STATE OF CALIFORNIA - DEPARTMENT OF TRANSPORTATION

CONTRACT CHANGE ORDER

CCO 1	Suppl. No. 0	Contract No. 04 - 0120S4	Road SF-80-12.7/13.2	FED. AID LOC.: NO FED AID

SHEET 6 OF 12

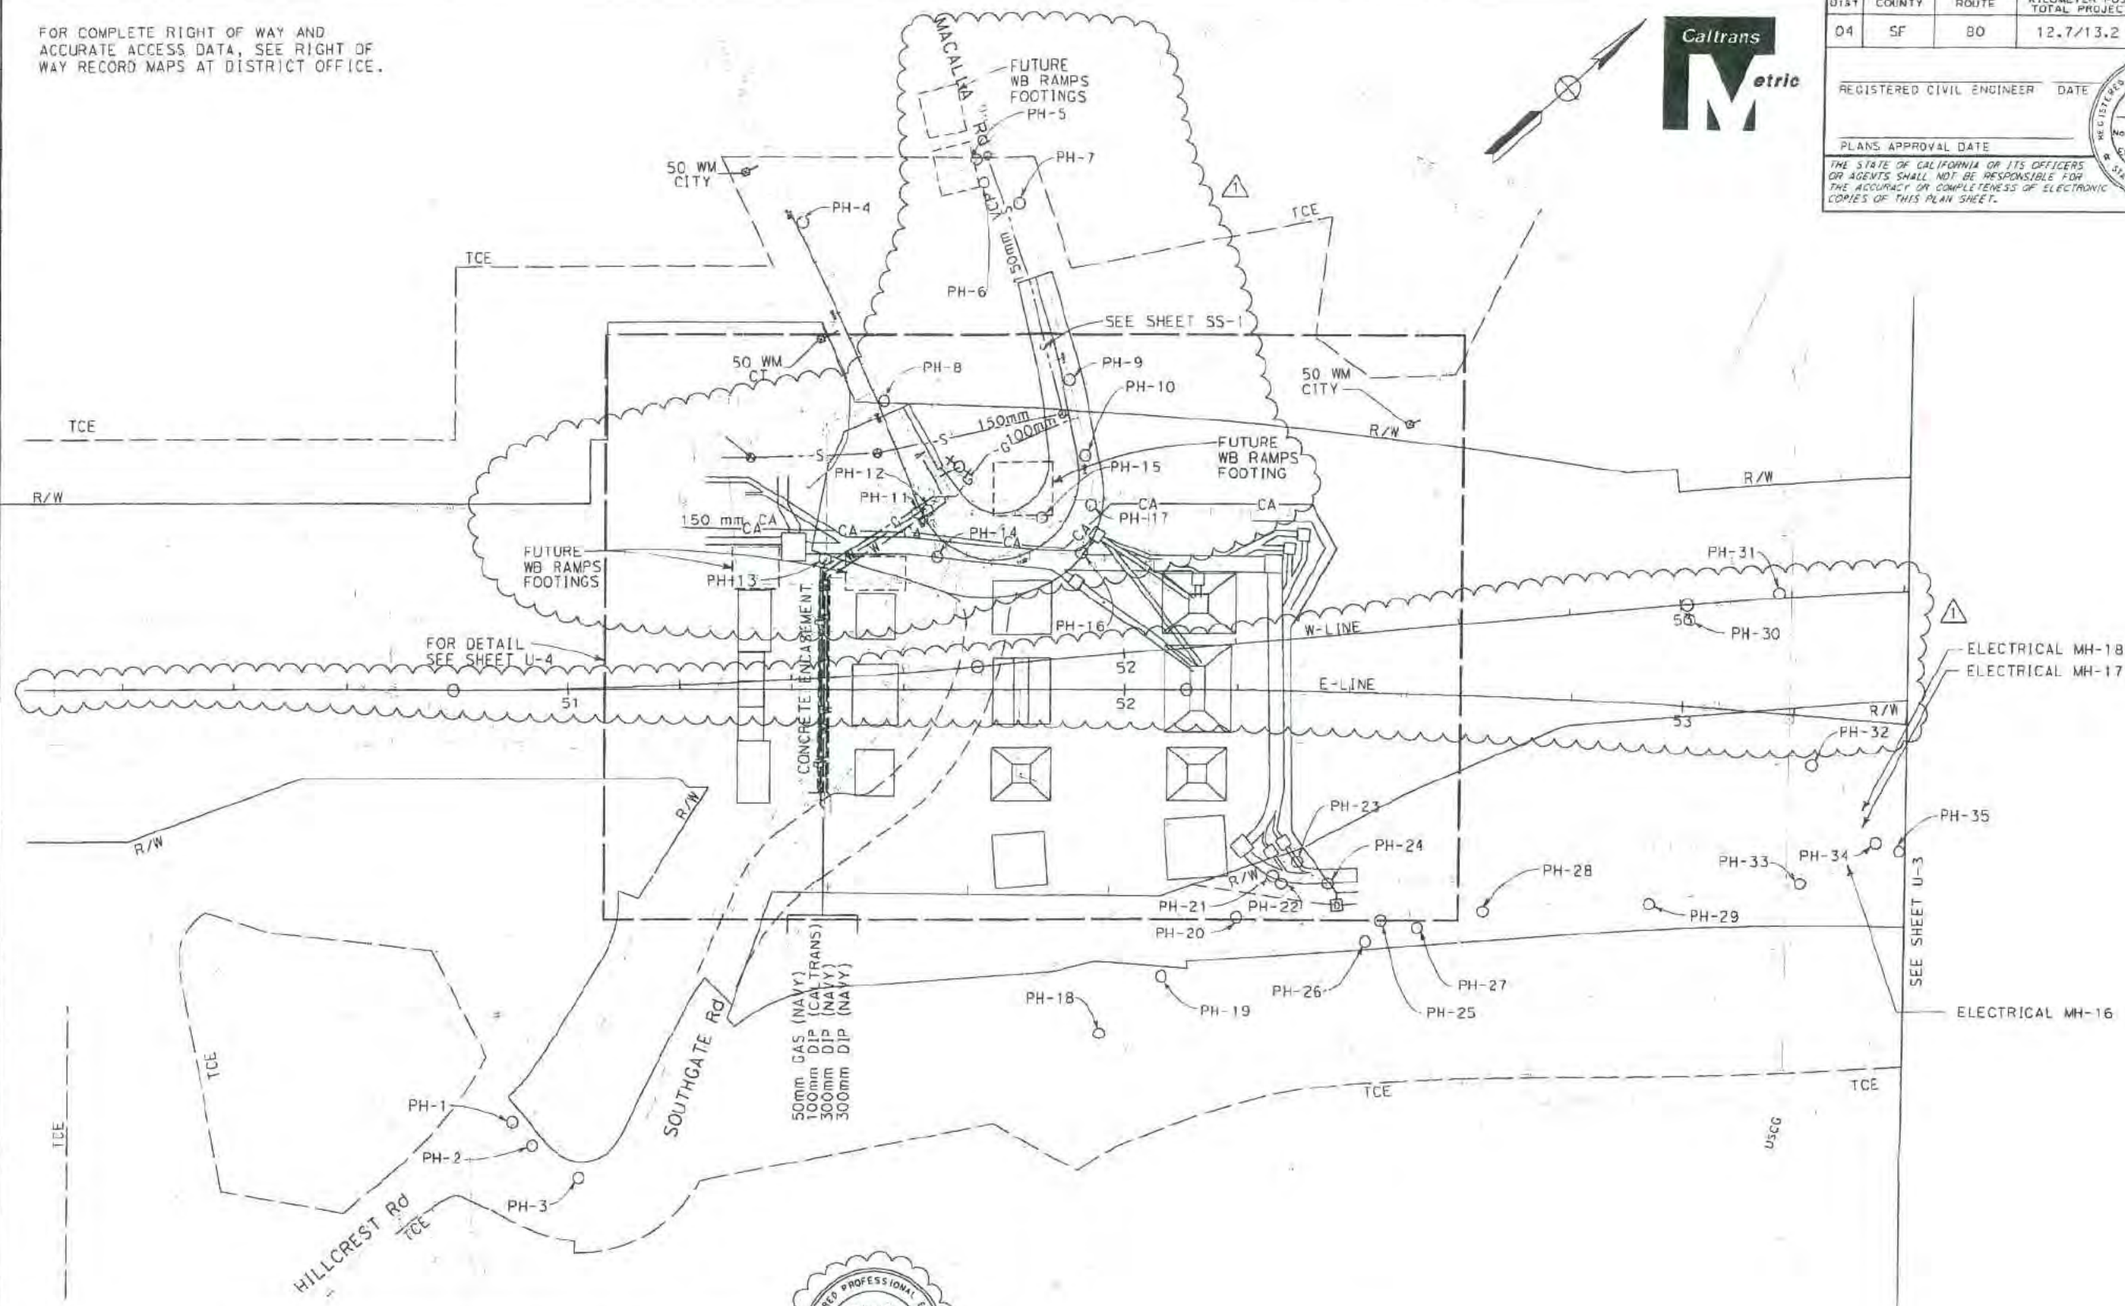
MARK	DATE	DESCRIPTIONS	BY	CH'D
1	8/5/10	RELOCATED GAS AND CA LINE	RL	SGC

TYPICAL FOR DUCTBANK AND MANHOLES

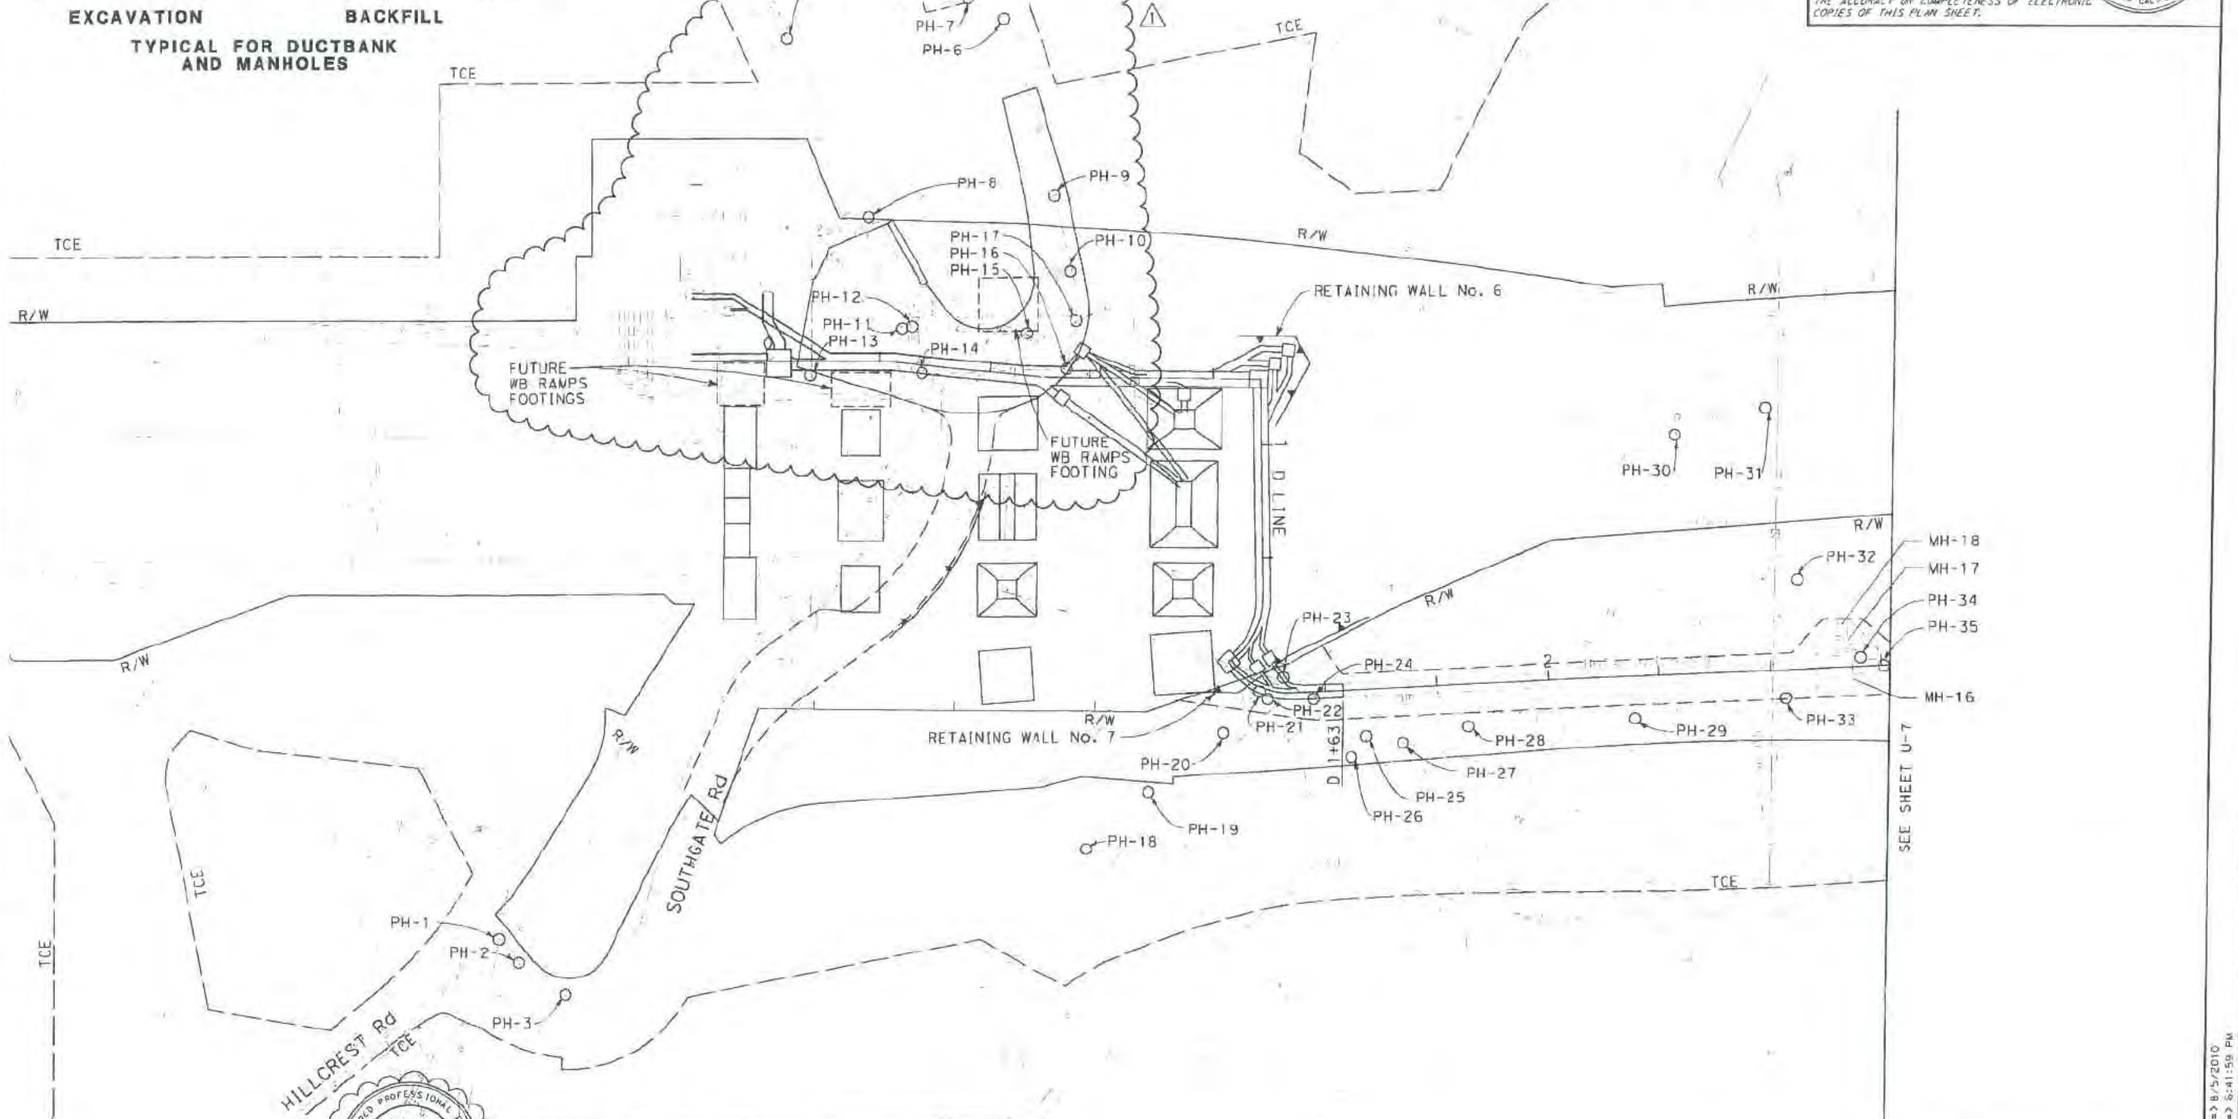
MARK	DATE	DESCRIPTIONS	BY	CH'D
1	8/5/10	REALIGNED ELECTRICAL DUCTBANK	RL	SGC

04-012054
CONTRACT CHANGE ORDER NO. 049-50
SHEET 3 OF 7

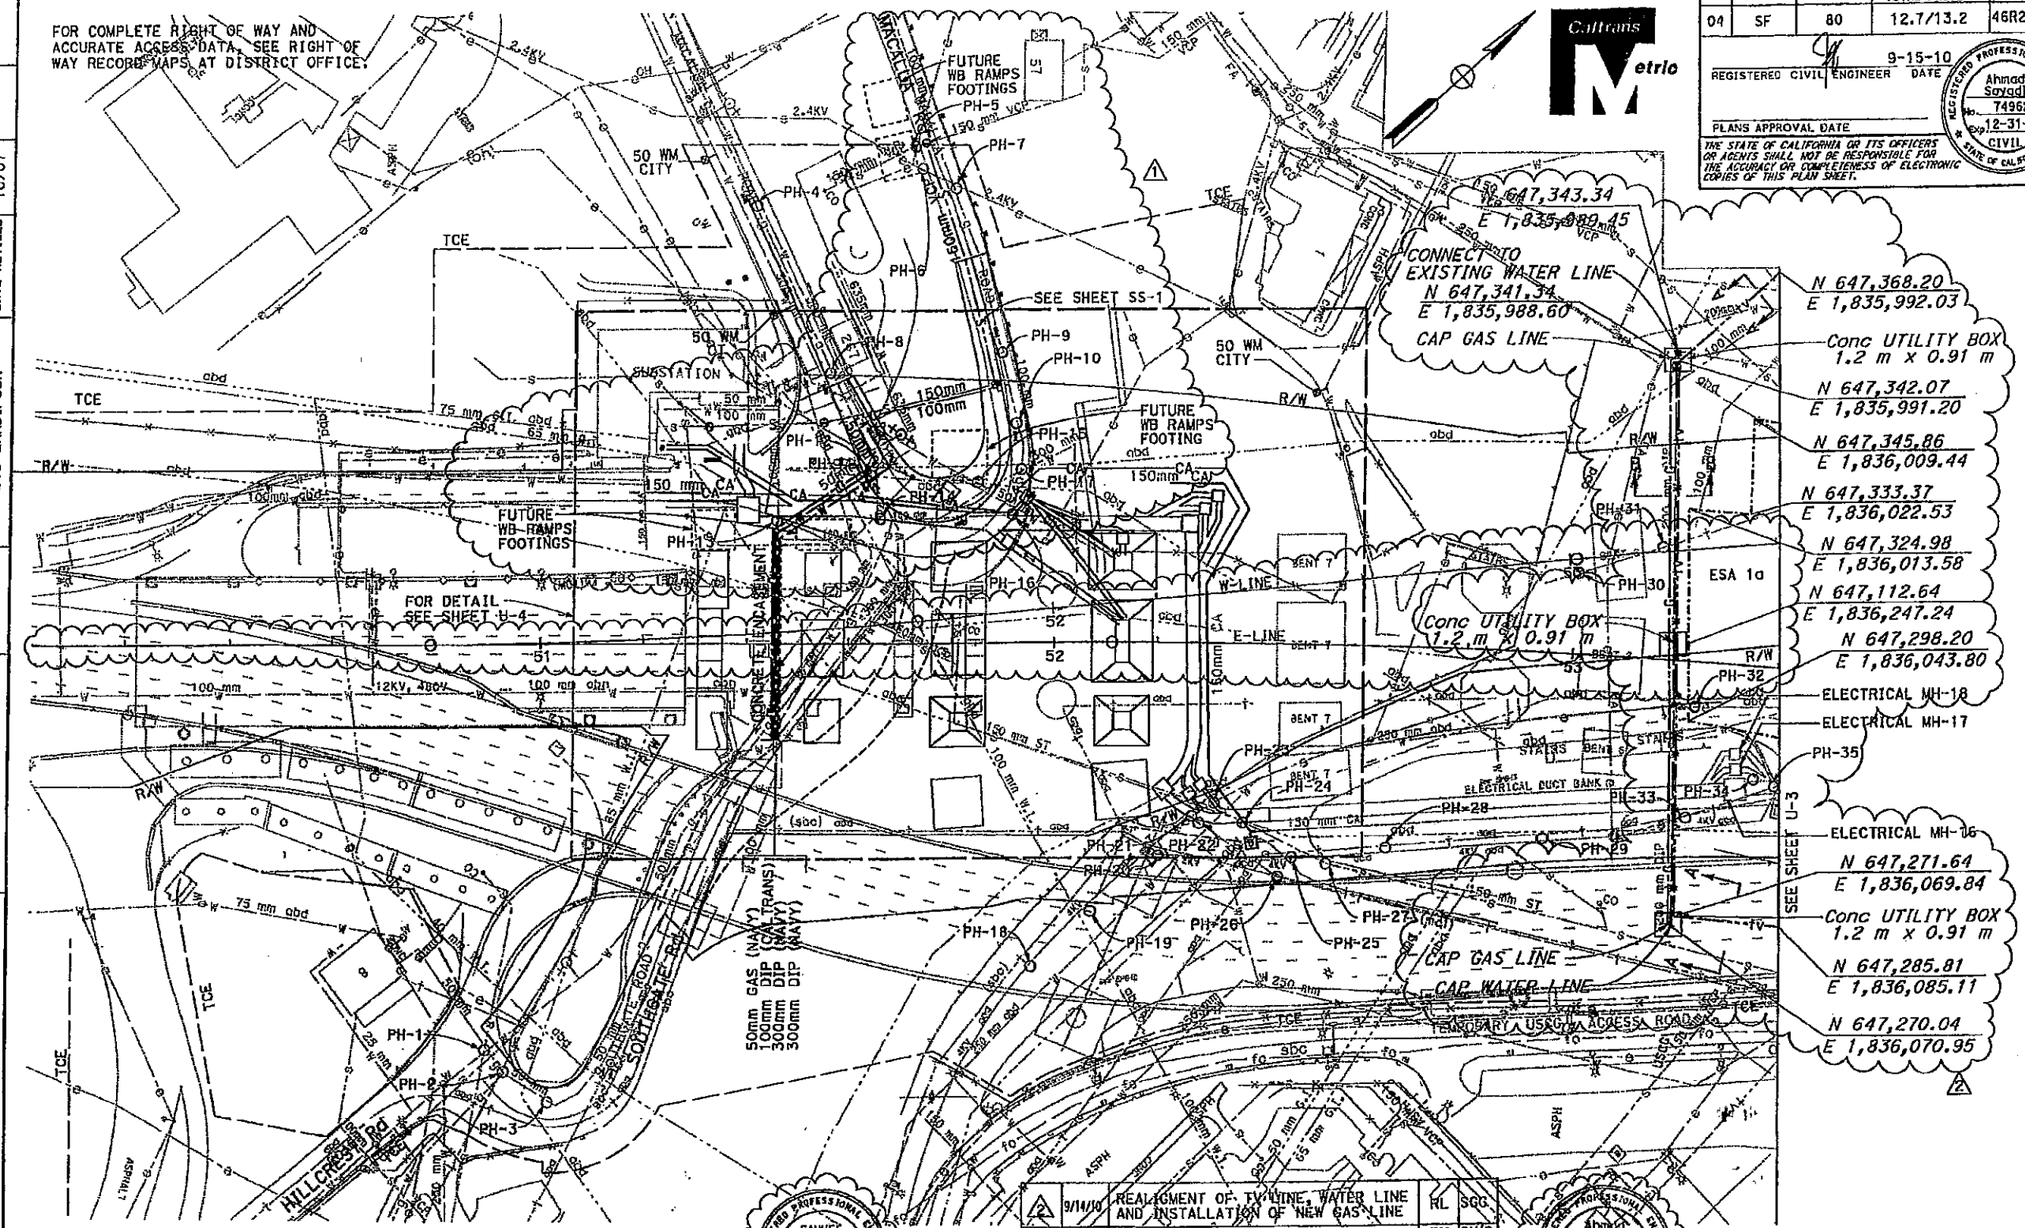
Furnish and install added Water Lines, Gas Line and Comcast duct (including pull rope, but not TV cable) at Bent W6 to Bent W2 Area, as shown on attached drawings 46R2 of 806, 47R3 of 806, 49R1 of 806, 67R3 of 806 and 66A of 806 (sheets 3 through 7 of this change order).

Water line construction shall be in accordance with Special Provision section 10-1.104 WATER MAINS, except that the trench for a portion of the Water line, gas line, and TV cable shall be a common trench where shown on section B-B of Sheet 66A (UD-13A).

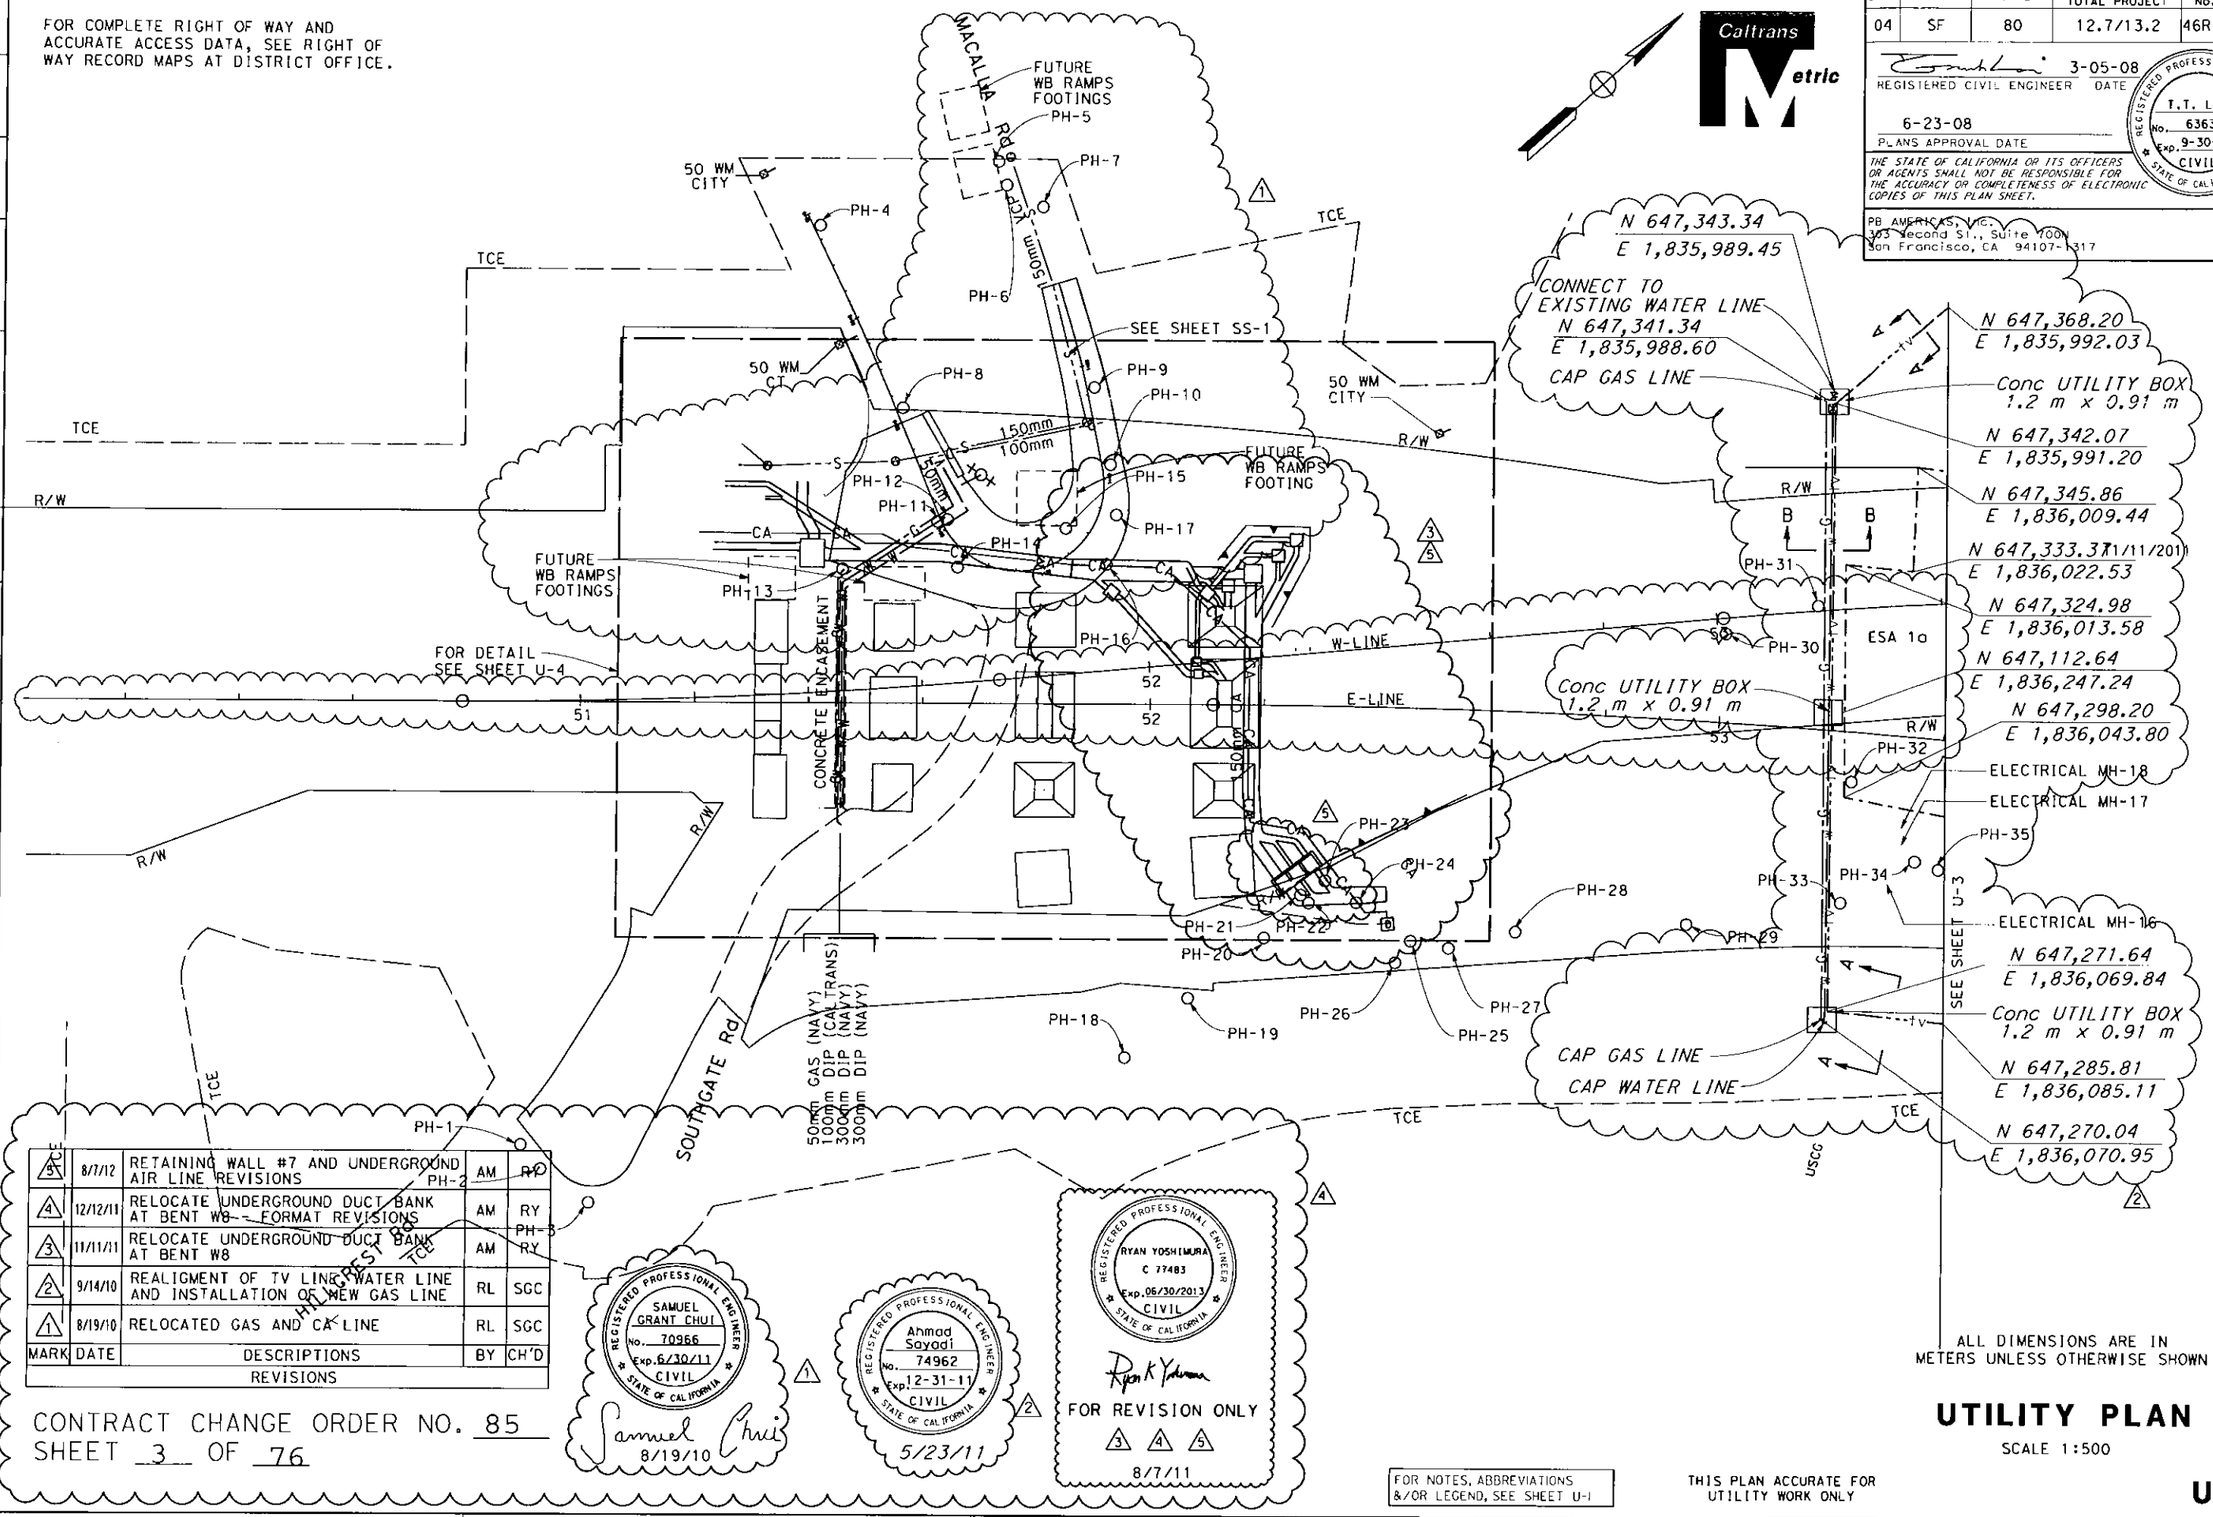
MARK	DATE	DESCRIPTIONS	BY	CH'D
5	8/7/12	RETAINING WALL #7 AND UNDERGROUND AIR LINE REVISIONS	AM	RY
4	12/12/11	RELOCATE UNDERGROUND DUCT BANK AT BENT W8 - FORMAT REVISIONS	AM	RY
3	11/11/11	RELOCATE UNDERGROUND DUCT BANK AT BENT W8	AM	RY
2	9/14/10	REALIGMENT OF TV LINE, WATER LINE AND INSTALLATION OF NEW GAS LINE	RL	SGC
1	8/19/10	RELOCATED GAS AND CA LINE	RL	SGC
